**City of Fairhope
Planning Commission Agenda
5:00 PM
Council Chambers
July 1, 2024**

This digital package has been condensed for size and some documents may not contain all the original pages. All submittals were reviewed in full by staff in preparation for the reports prepared for the Planning Commission.

SD 24.05 - The Proper

SCOPE OF WORK:

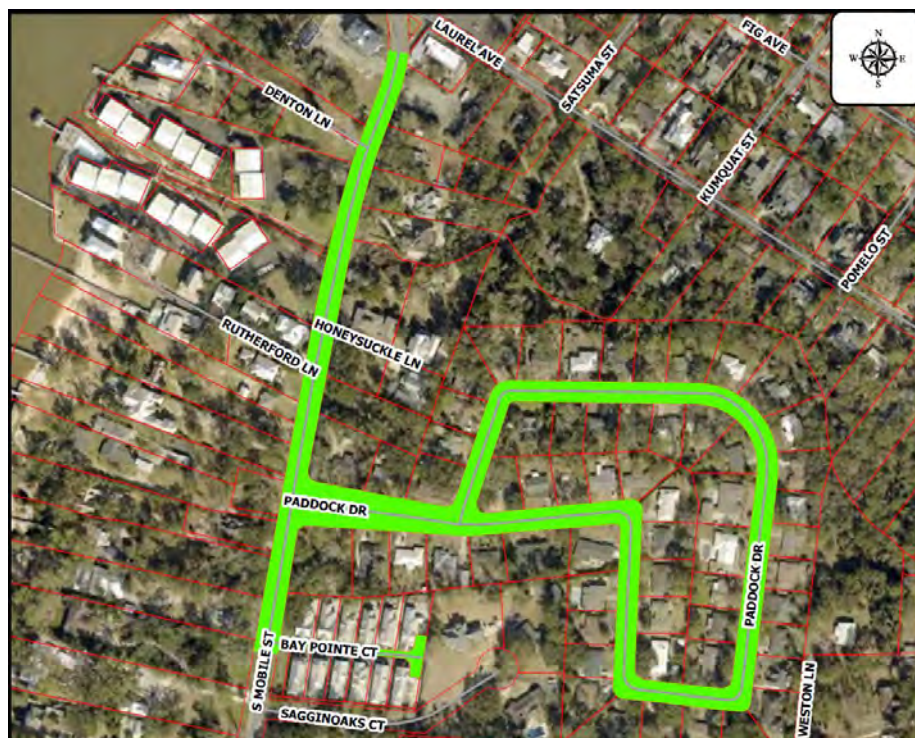
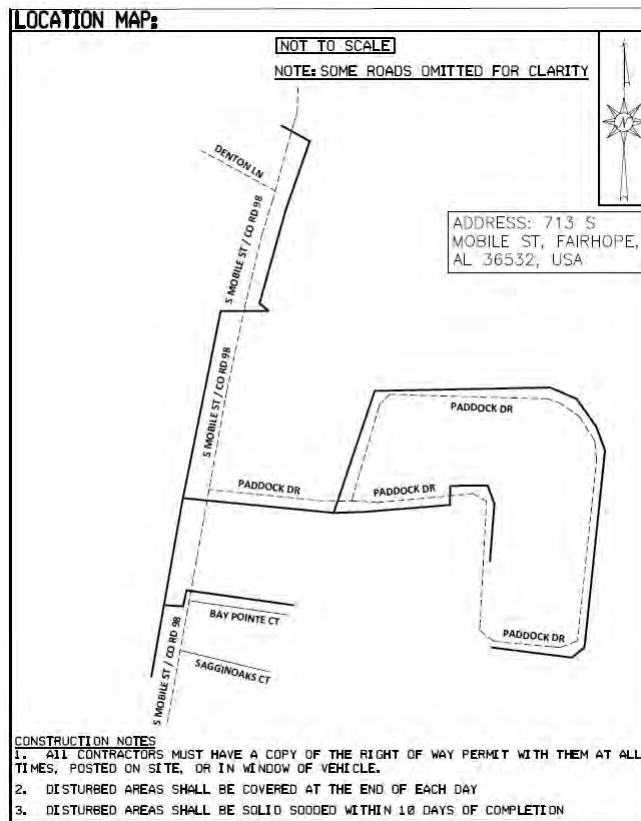
DIRECTIONAL BORE 5489' BURIED FIBER CABLE AND 1523' INNERDUCT IN ROW
ALL BORE WILL BE A MINIMUM OF 36" DEEP AND 48" UNDER THE ROAD.
PLACE 28 PED AND 23 HANDHOLE.

- Provide Door Hangers at preconstruction meetings which shall be approved prior to distribution and work.
- Use of portable A-frame style signage at the entrance and exit of work sites.
- Applicant shall dedicate a Point of Contact to answer citizens questions.

- Hand holes/boxes shall not be allowed to be installed in sidewalks. The applicant shall review the sidewalk plan to determine if there are any conflicts. The applicant shall coordinate with the ROW inspector to resolve any conflicts.

Site Plan

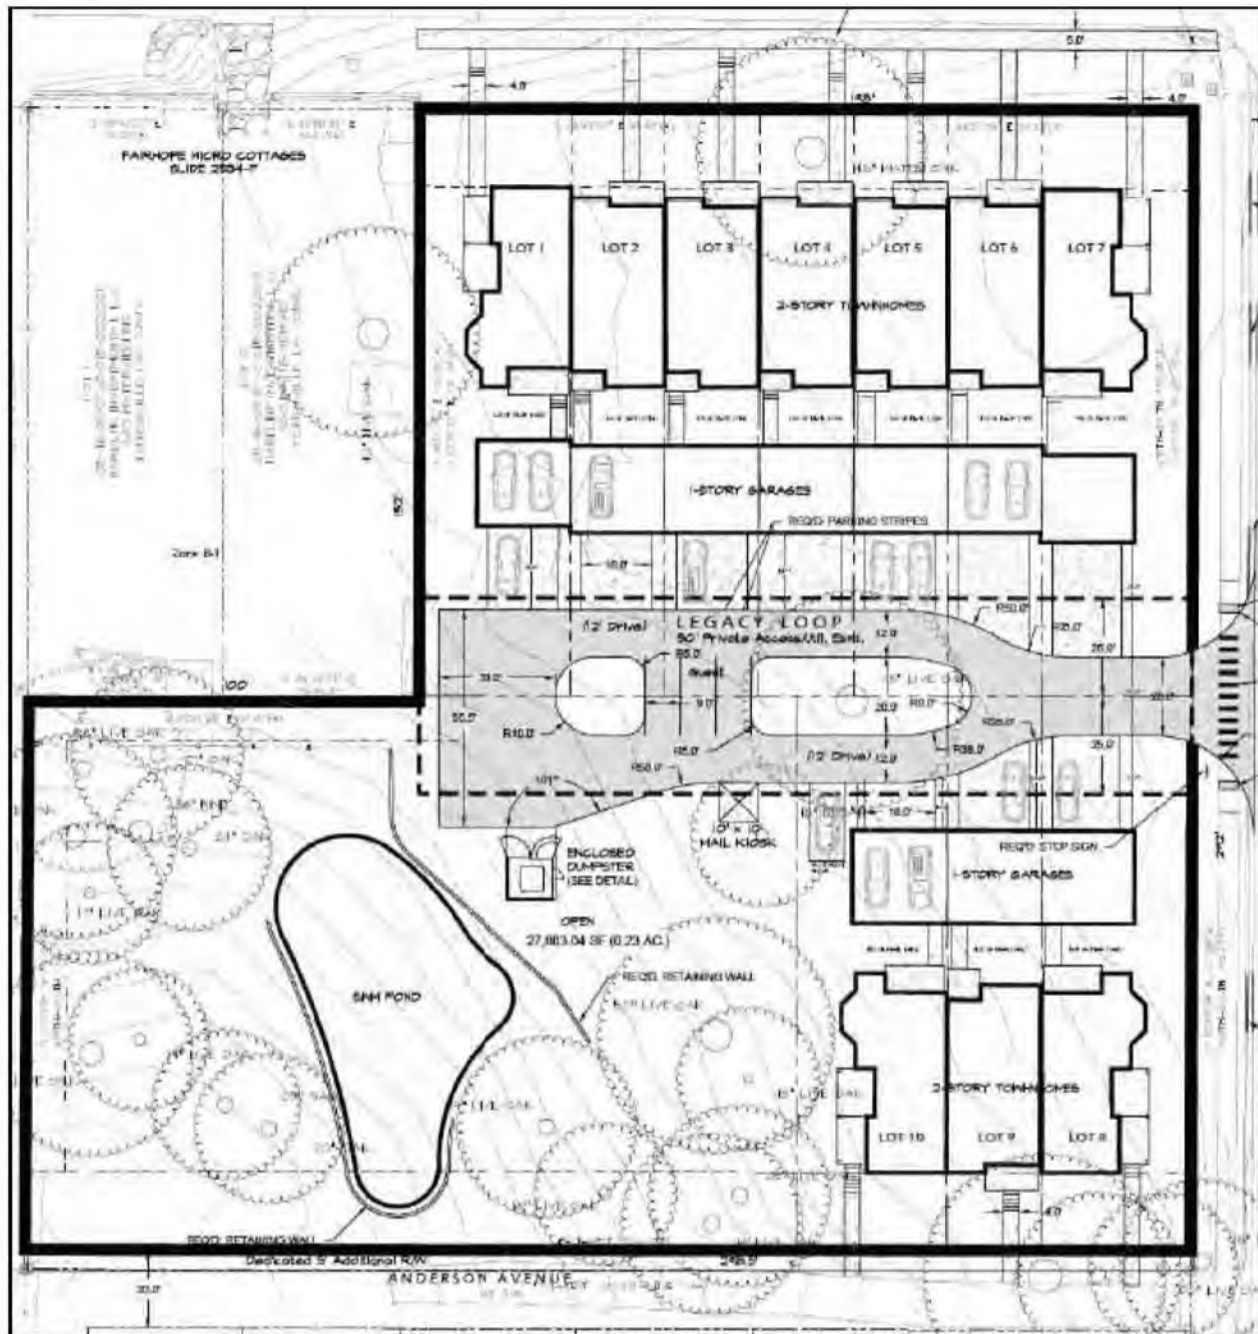
The applicant has provided a site plan illustrating two (2) rear-loading rows of townhomes. There are seven (7) facing Nichols Avenue and three (3) fronting Anderson Avenue. Two (2) styles are being offered. *See Architectural Plan.*

Although both sets of buildings front a public right-of-way, the two (2) clusters of undulated townhomes share a common rear entrance in the form of a rear access drive, Legacy Loop. There are four (4) to six (6) guest parking spaces in this area. Site Plan shows six (6); whereas, Site Data Table has four (4) guest parking spaces. There are a total of 24-26 parking spaces provided. Each unit will have a two (2) car garage. Each unit has an 18 ft wide driveway. The outside parking spaces provided surpass the parking

Photo taken May 28, 2024.

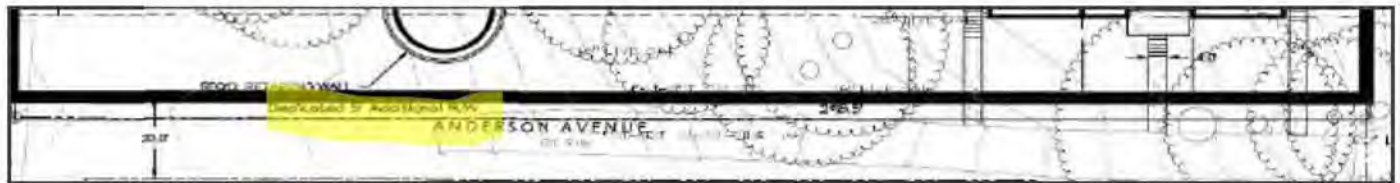
Anderson Ave./St. is a right-of-way platted in 1946. Currently, there are no improvements installed within said right-of-way. Applicant desires for Anderson Avenue to remain “as is” and not provide any improvements beyond clearing overgrowth and installing sidewalks to the units. Applicant states that there is pedestrian access “via such frontage” on Anderson Avenue.

A third-party title search was conducted; whereas, it was opined that the ROW for Anderson Avenue is 15 ft. The County ROW confirmed a 15 ft ROW from a better version of Slide 116-A. The Applicant dedicated a 5 ft strip from its own property fronting Anderson Avenue to make a 20 ft ROW for Anderson Avenue.
